Timber Valley Estates – Preliminary Plat

Request: Preliminary Plat Approval of a Major Subdivision Plat

MAJOR PRELIMINARY PLAT FOR: TIMBER VALLEY ESTATES POLK COUNTY, IOWA

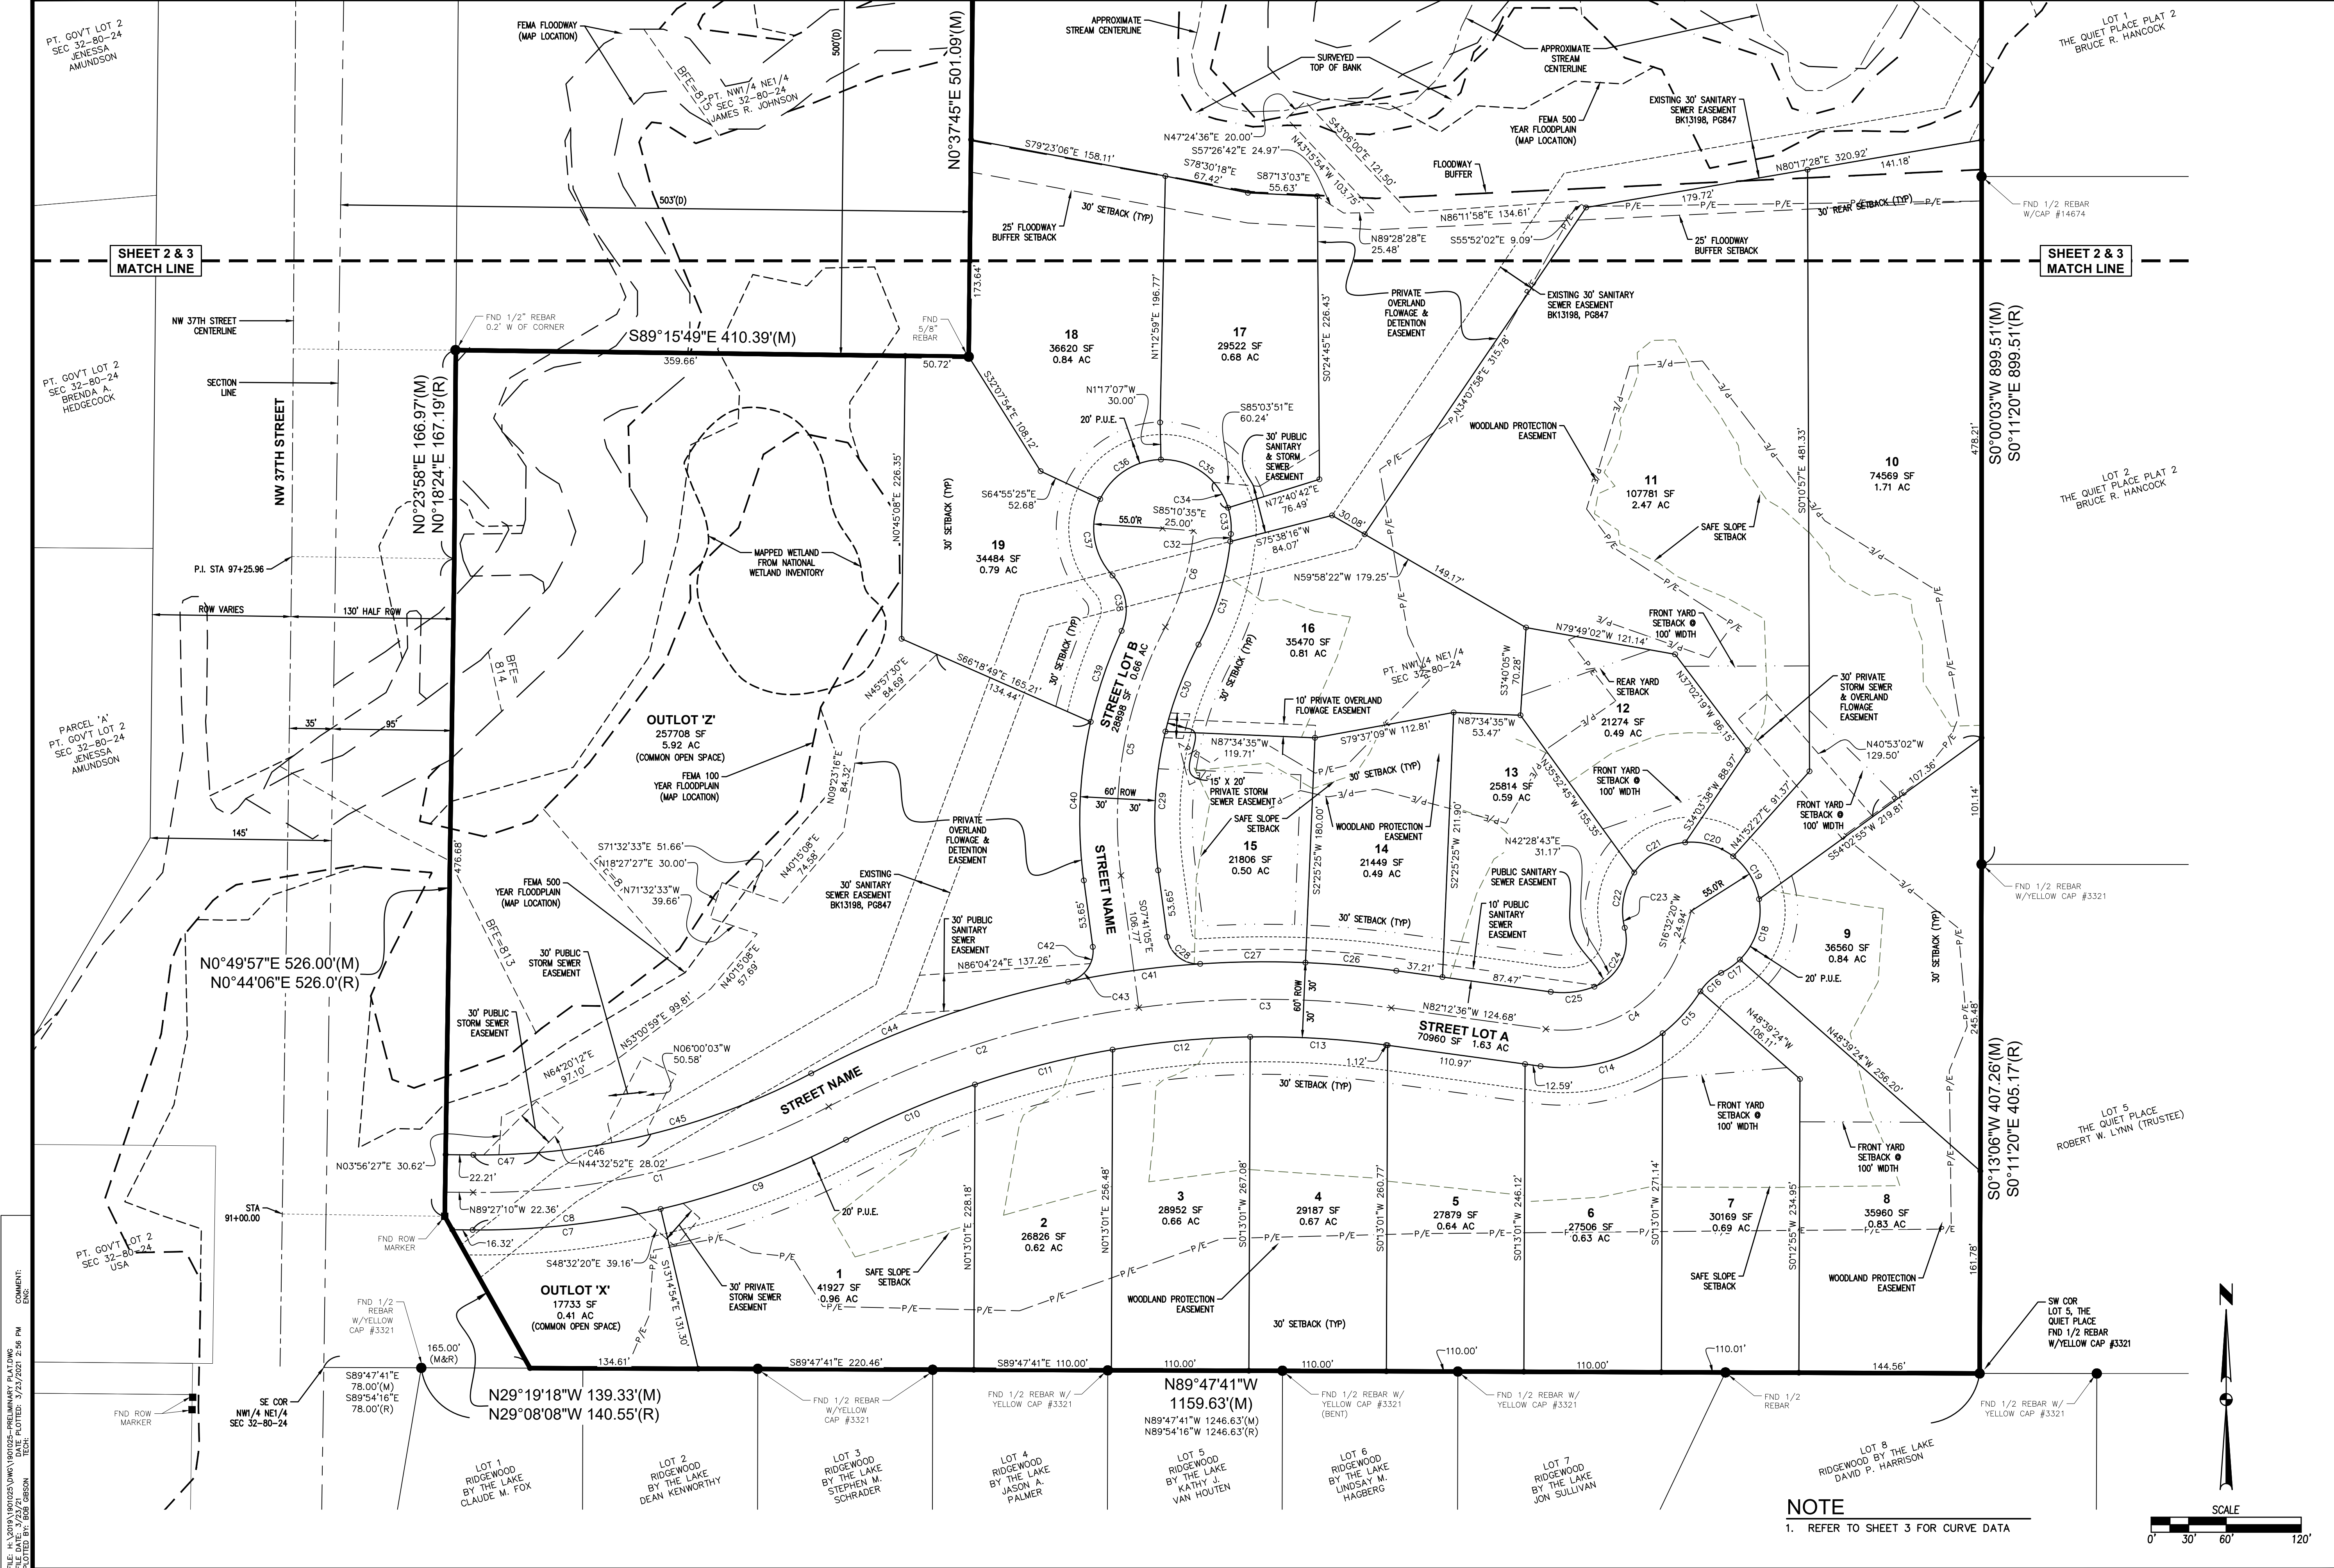
This preliminary plat (*Attachment 'B'*) proposes to create 19 single-family residential lots and three (3) outlots on a 32-acre parcel zoned "RR" Rural Residential District utilizing the Cluster Development option. The subject property is located approximately 350-feet northeast of the NW 37th Street and NW 75th Place intersection. The City of Ankeny corporate limits are approximately ½ mile to the east and the City of Johnston corporate limits are approximately ⅓ mile to the west. The property is currently vacant with a majority of the property covered in woodlands and a large area of floodplain surrounding Rock Creek within northern and western portions of the parcel. The subject property has approximately 800 feet of frontage along NW 37th Street, a paved collector roadway maintained by Polk County. The proposed plat includes one (1) access with two (2) proposed cul-de-sac street extensions. Lot A is an east west cul-de-sac street extension and extends 1,188-feet from NW 37th Street. The majority of the lots (14) have frontage along Street Lot A. Street Lot B is the second cul-de-sac extension, located at a north central point along Lot A, and extends south to north with a length of 1,150-feet from NW 37th Street and provides frontage to five (5) lots. The maximum cul-de-sac length is 600-feet as required by the Subdivision Ordinance. The developer has confirmed through response to review comments that the profile grade for the streets will meet the maximum street grade of 6%.

The proposed 19 single-family residential lots generally have widths between 110 and 271 feet and areas ranging from 21,274 square feet to 107,781 square feet (2.47 acres). The minimum

lot size is 20,000 square feet and the minimum lot width requirement is 100-feet for standard lots within the Cluster Development option. The average size of the proposed lots is approximately 30,000 square feet with most of the lots being much larger than the minimum allowable lot size minimizing impact and providing greater protection of natural resources. The Cluster Development option requires 25% permanent open space to be maintained on the subject property. The proposal provides 42% open space within Outlots 'X', 'Y' and 'Z'. Flag lots shall not exceed one (1) acre in size in areas with public sanitary sewer as required by the Subdivision Ordinance. Both Lots 10 and 11 exceed the one (1) acre standard with Lot 10 proposed as 1.71-acres in size and Lot 11 proposed as 2.47-acres in size.

The site has a significant variation in topography with a high point of 906 feet within the southeast corner of the site and a low point of 810 feet along the stream of Rock Creek in the north and northwest portions of the site. The topography of the site introduces unique challenges in providing streets and utility services. An existing WRA Polk County trunk sanitary sewer line and associated 30-foot wide sanitary sewer easement diagonally bisects the subject property. The proposal requires approval from the WRA for fill depths and locations of crossing the trunk sanitary sewer for the proposed streets.
